**CITY OF NAPOLEON  
BUILDING CONSTRUCTION PERMIT  
(1, 2 or 3 Family Dwelling)**

Zoning "S" Intended use of Building: New in ground Swimming Pool

# RESIDENTIAL PLAN CORRECTION SHEET

**ADDENDUM to Permit No.** \_\_\_\_\_  
**Owner** LABORS  
**Location** 610 BUNYON

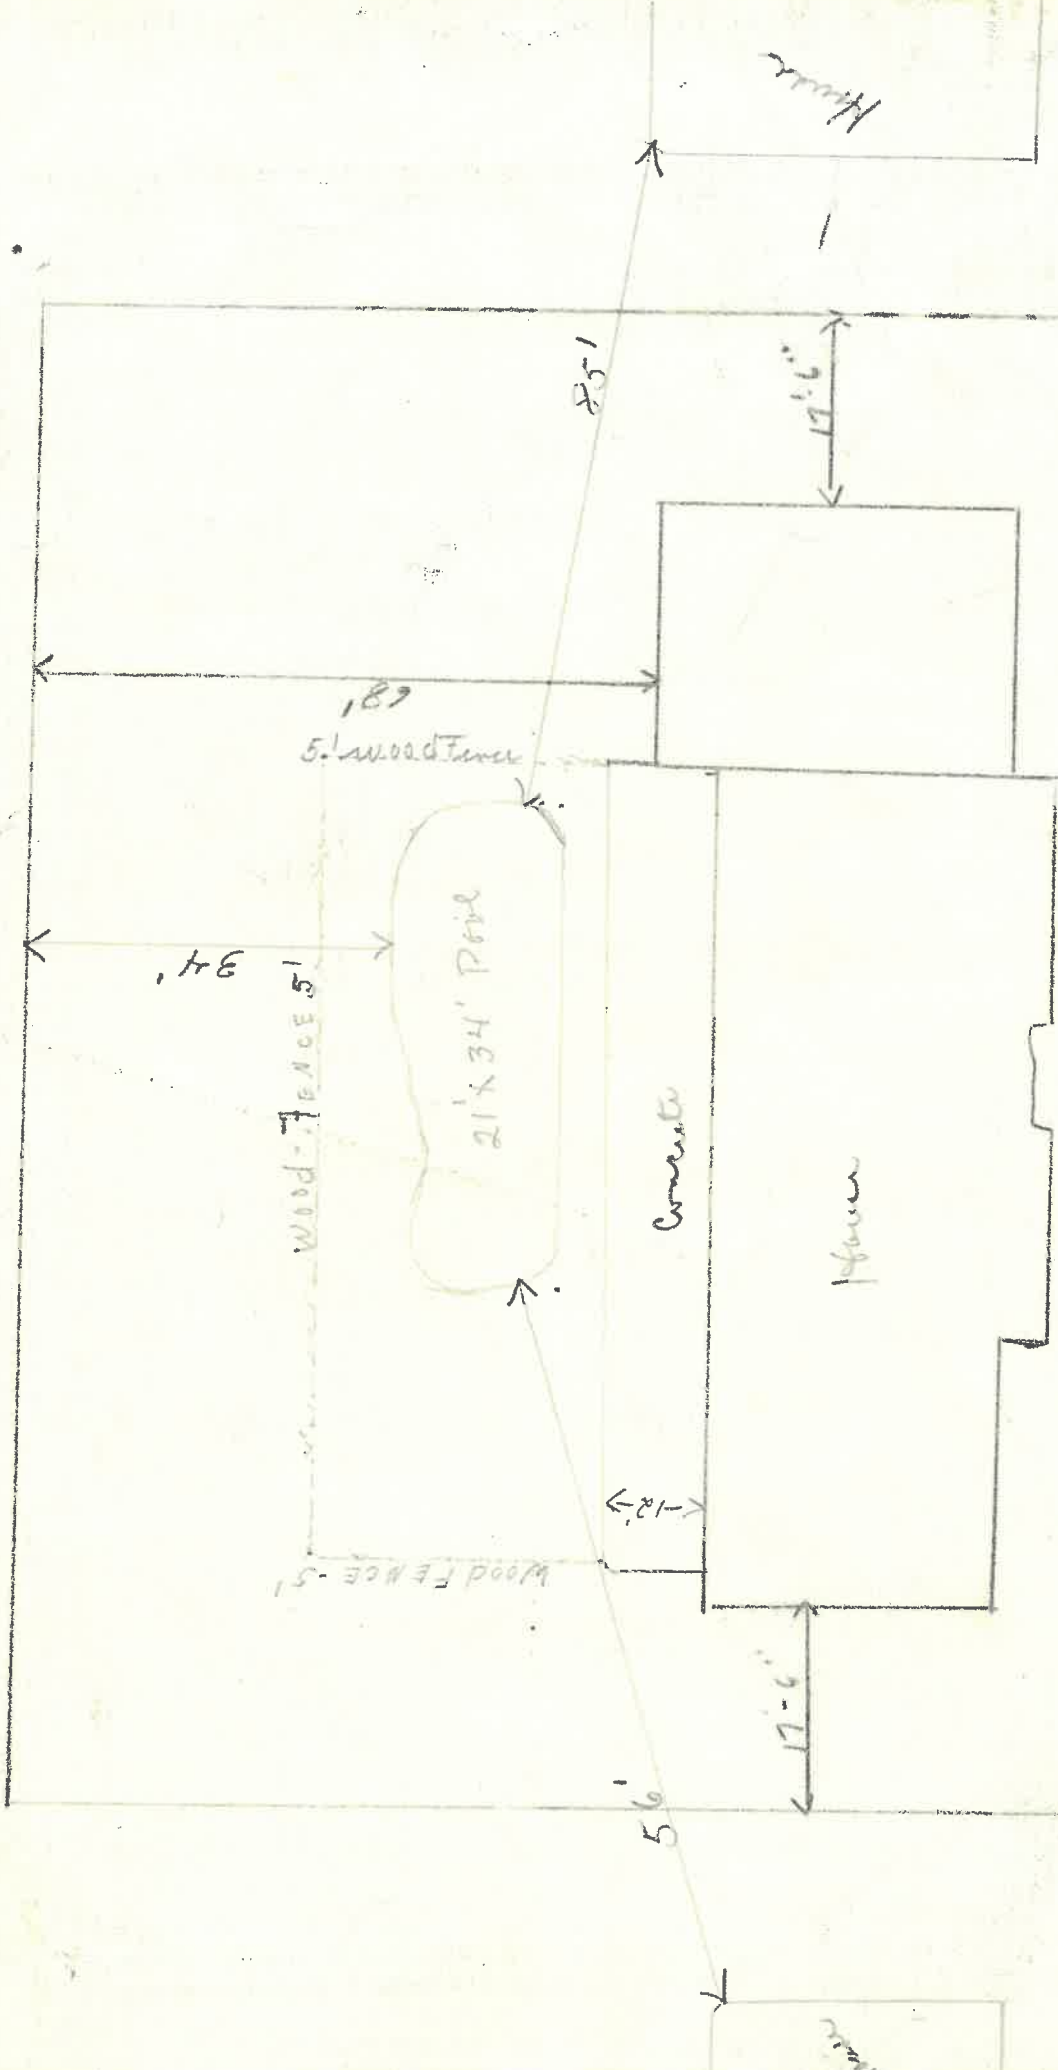
Additional Information: Provide approved manner of discharging Pool water that will not create a nuisance to adjoining property. Sec. 425.6.3 of the Bldg. code.

NOTE: 8/21/76 LEFT NOTE 2/3" FLOOR DRAINS TAPPED INTO BLDG SEWER LINE MUST BE TRAPPED. AUF 9/16/76 INFORMED BY OEDY TRAP INSTALLED IN FRONT WHEN CONNECTED TO SEWER LINE. BACKFILLED PRIOR TO INSPECTION: AUF

8/15/76 PROJECT COMPLETED; REQUIRED 5' FENCE INSTALLED AUF  
Certificate of Occupancy Issued ---
